APPENDIX F

FLOODPLAIN/WETLANDS ASSESSMENT

Table J-2. DOE responses to comments on Draft EIS (continued)

Figure G-1. Exposure Pathways Considered in Radiological Impact Assessments

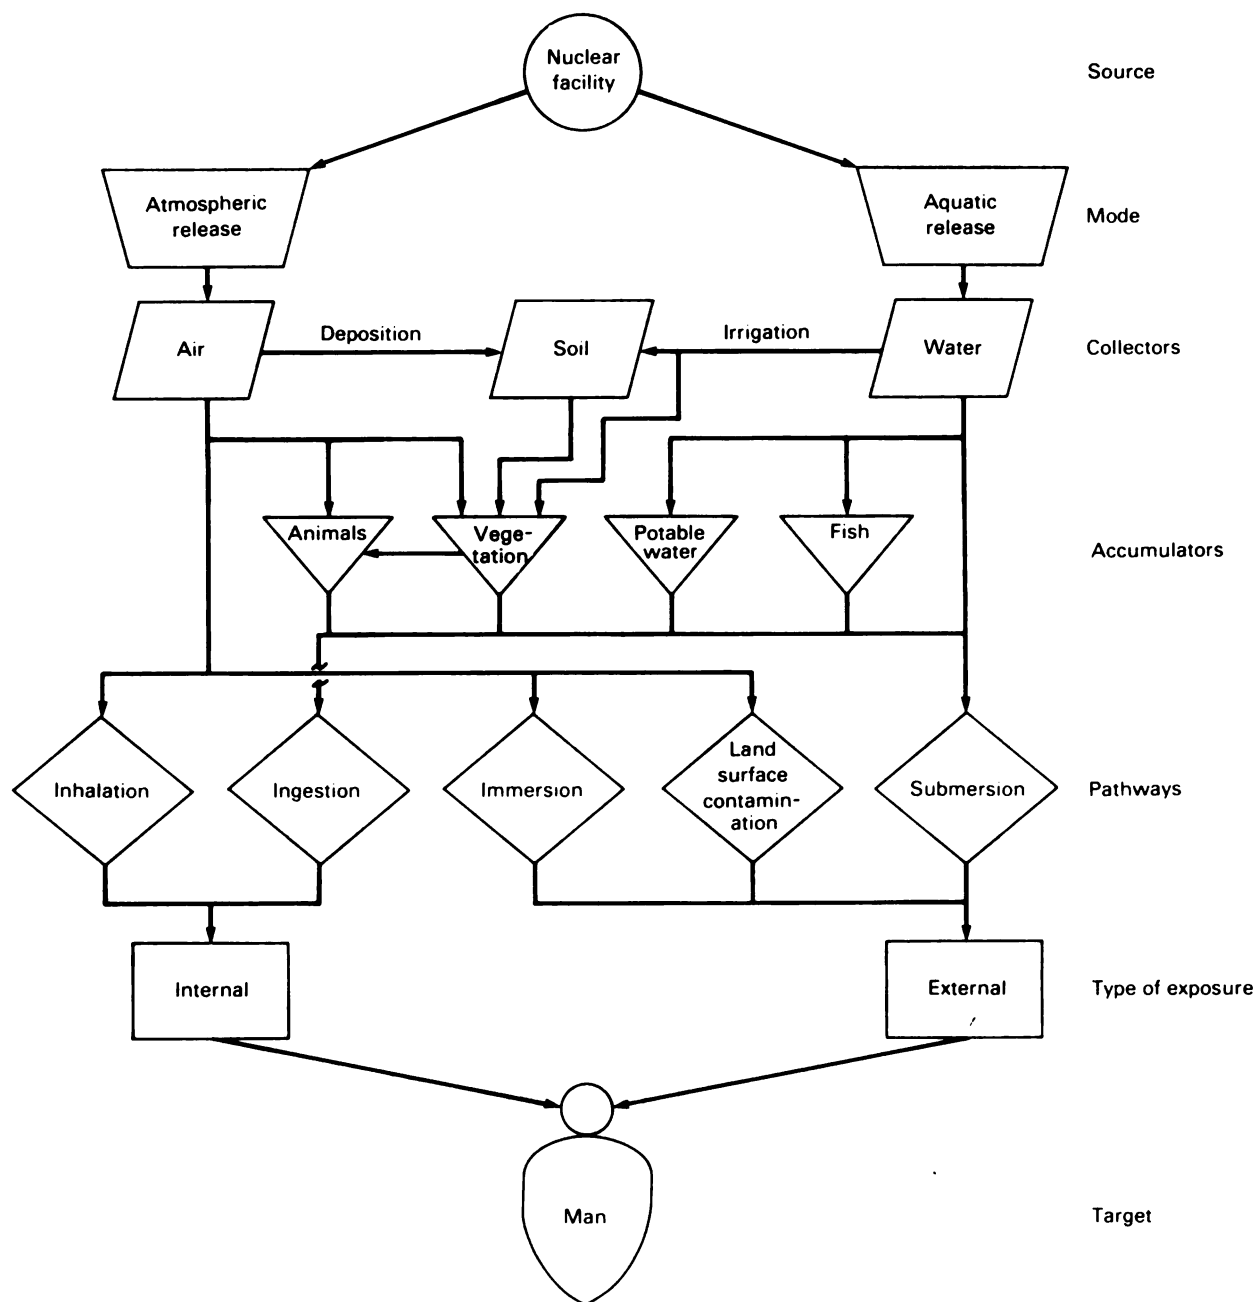
Comment number	Comments	Responses
2.	The environmental pathways identified in Appendix G (Figure G-1) cover all possible emission pathways that could impact on the population in the environs of the Savannah River Plant. The radiation dose calculation methods and assumptions presented in Appendix D have provided reasonable estimates of annual dose to the maximally exposed individual and collective dose to the population within the 80-kilometer area from operation of alternative cooling water systems for the C- and K-reactors. Results of these calculations are shown in Appendix D, Tables G-7 through G-38, and indicate that the doses are minimal and are well within current radiation protection standards.

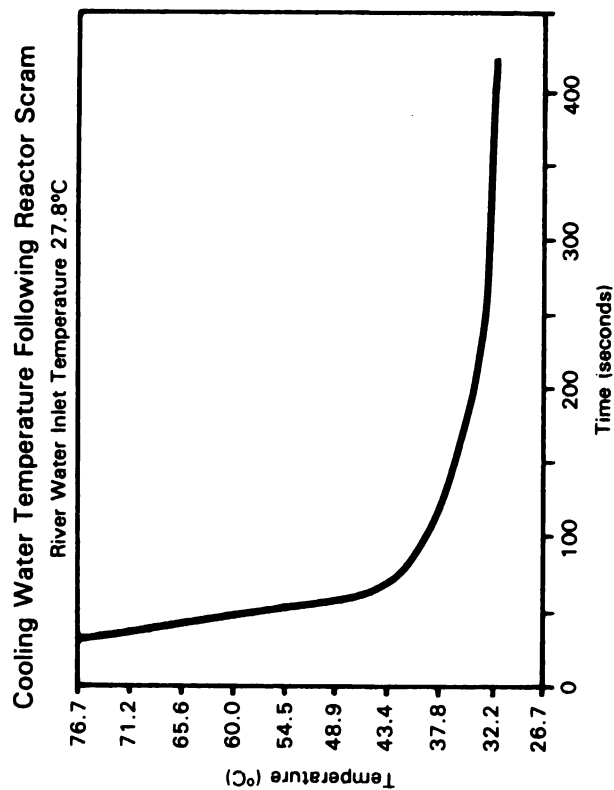
BC-15 Environmental Systems Corporation has reported An estimate of cooling performance with (see Attachment A): "Based on data acquired by deficient design was addressed for the type Environmental Systems Corporation from their own systems being considered for SRP reactor acceptance and performance tests of over twenty coolant discharges. A consultant was
